BOARD ACTION REPORT – APPEALABLE ITEM

Project Name: Delray Beach Public Library
Project Location: 100 W. Atlantic Avenue
Request: Approval of a Class I Site Plan Modification
Board: Site Plan Review and Appearance Board
Meeting Date: July 25, 2018

ITEM: **Delray Beach Public Library (2018-135):** Class I Site Plan Modification associated with architectural elevation changes for the removal of the fountain located on the north elevation facing Atlantic Avenue.

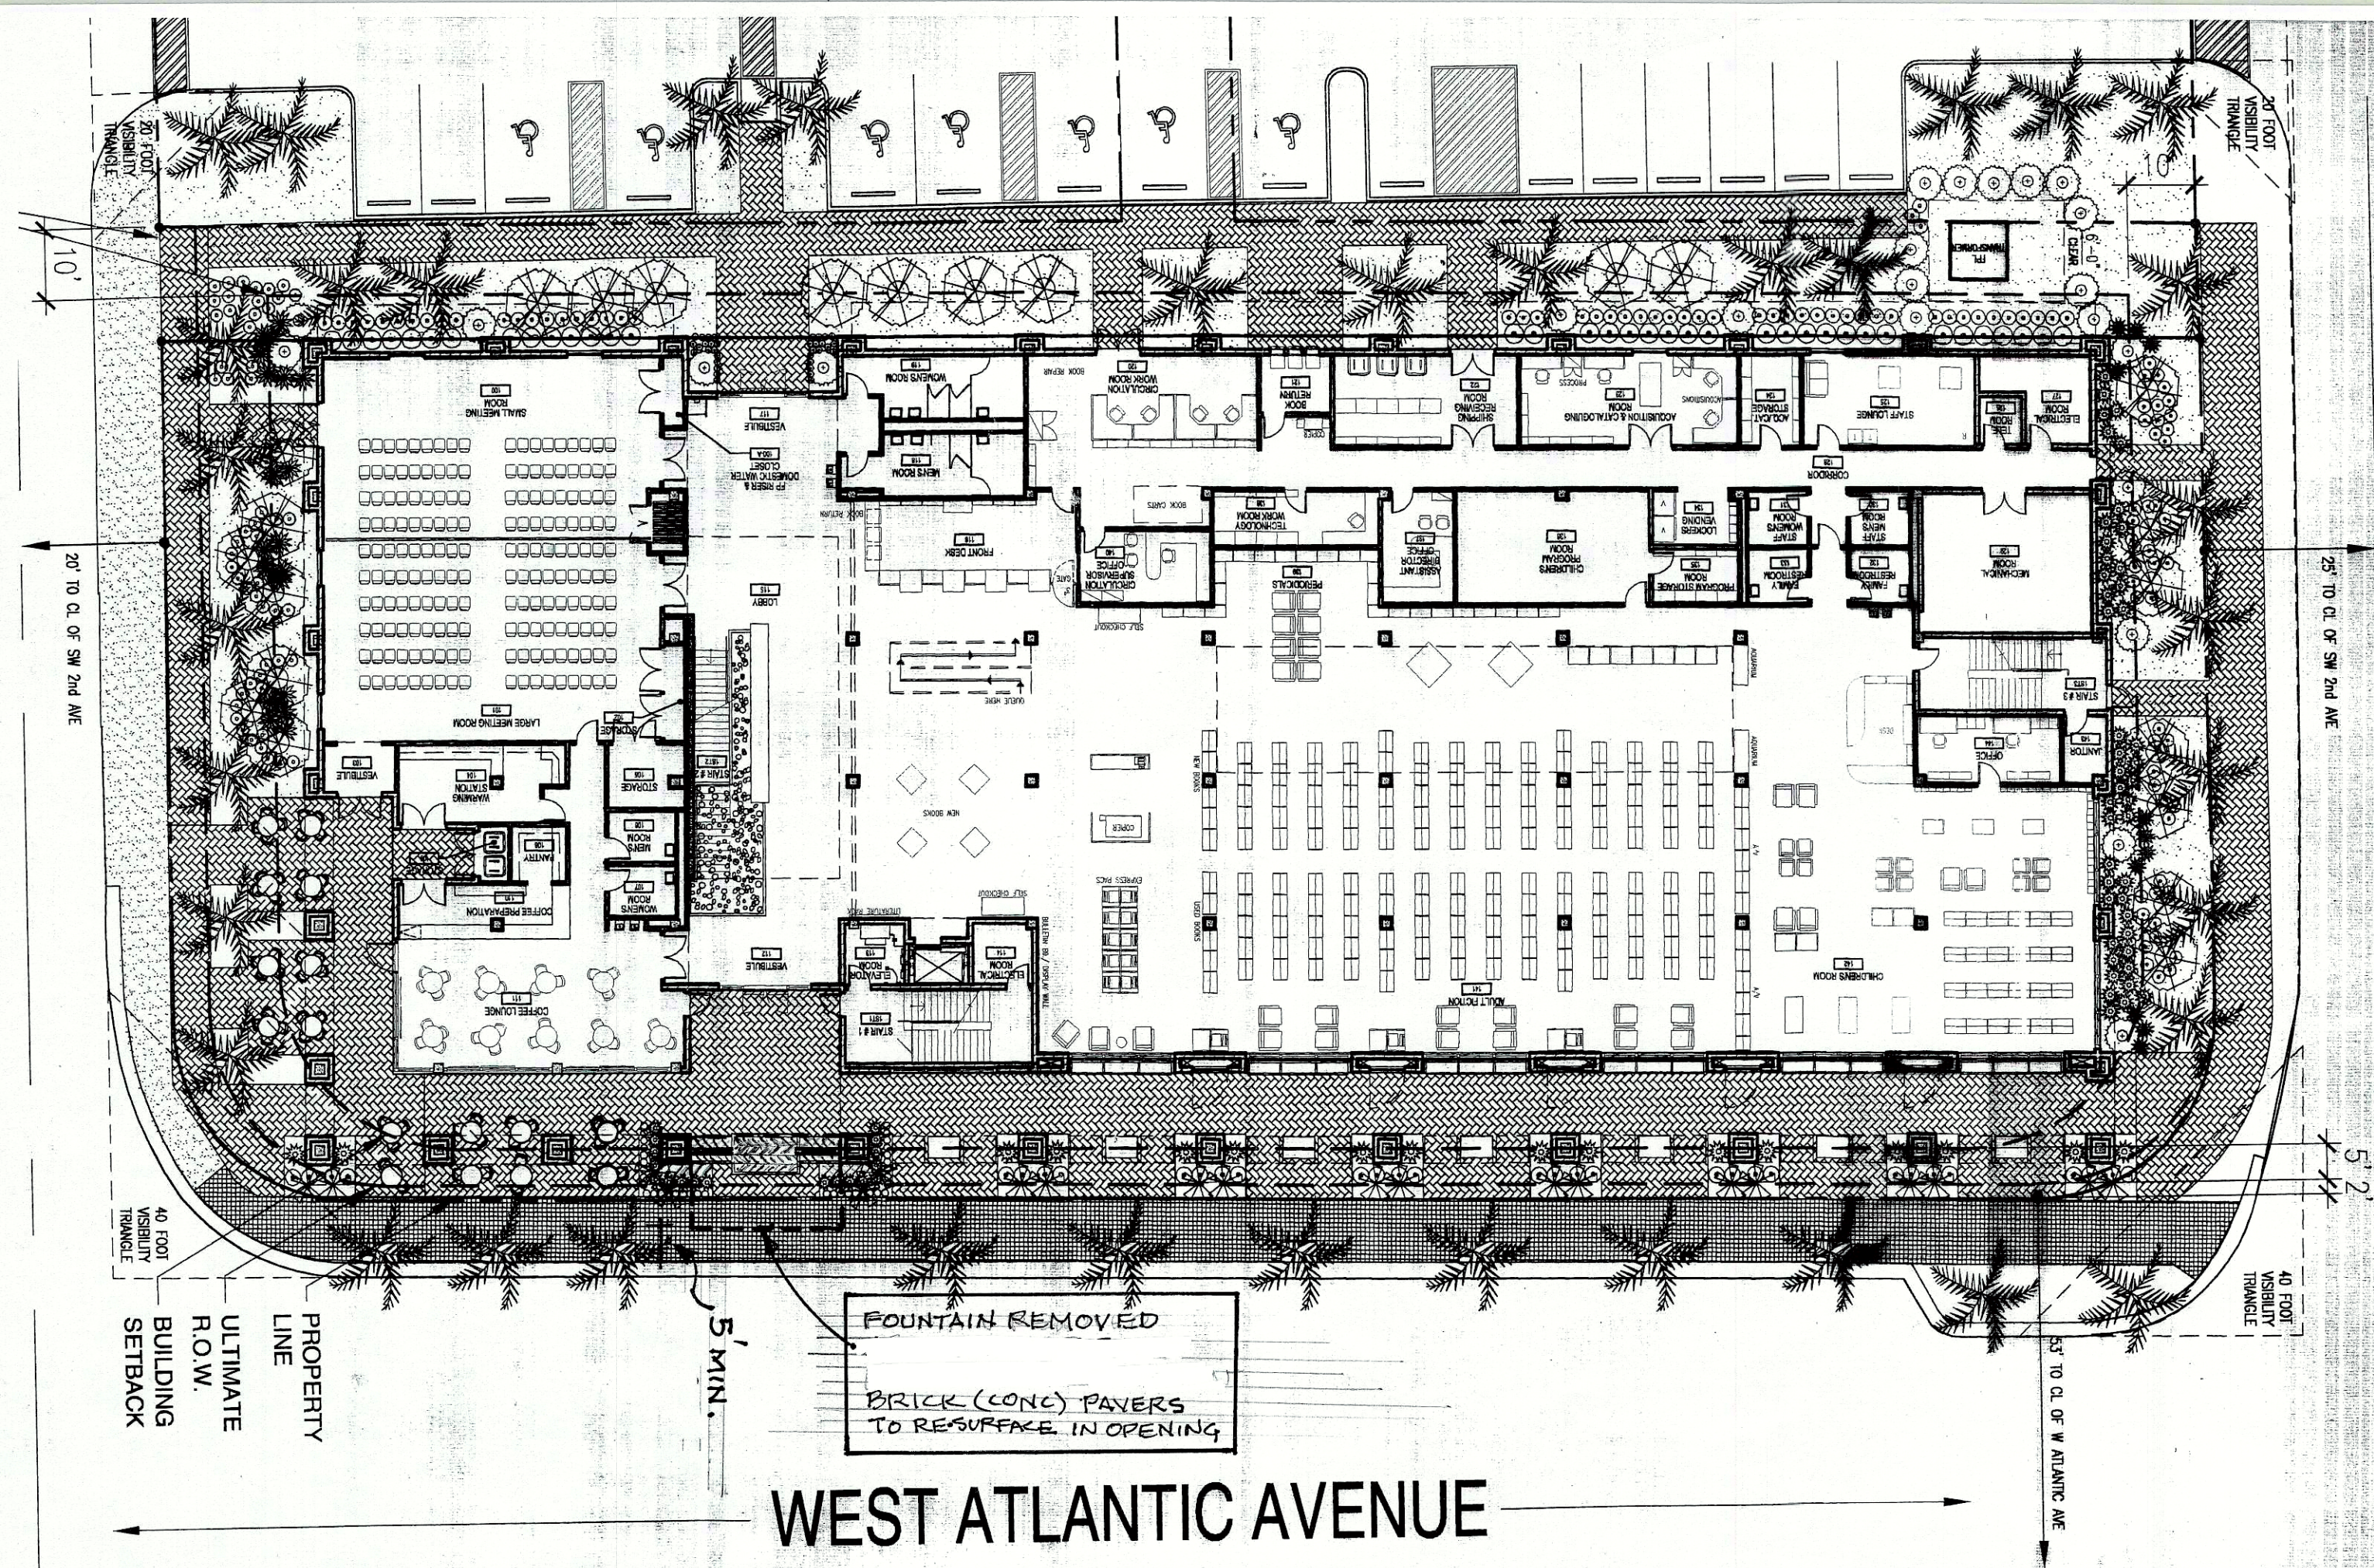
Now before the Board is a Class I Site Plan Modification associated with architectural elevation changes for the removal of the fountain located on the north elevation facing Atlantic Avenue.

The fountain wall located on the north elevation is an additional wall in front of the entrance, not directly connected to the structure. With the removal of the fountain, an opening will be created as a result. In its existing condition, the fountain blocks the entrance of the library. With the creation of this opening (5 ft. wide and 13.5 ft. long), the library entrance will be visible from Atlantic Avenue. The wall will reflect existing stucco with tex coat finish in any areas that are affected.

REMOVE FOUNTAIN, CAP OFF
WATER AND ELECTRIC LINES
RESURFACE PAVED AREA ON
COMPACTED FILL - PLACED IN A
SILICA SAND BASE

GLAZED OPENING IN STUCCO WALL, FOUNTAIN BELOW
FOUNTAIN REMOVED
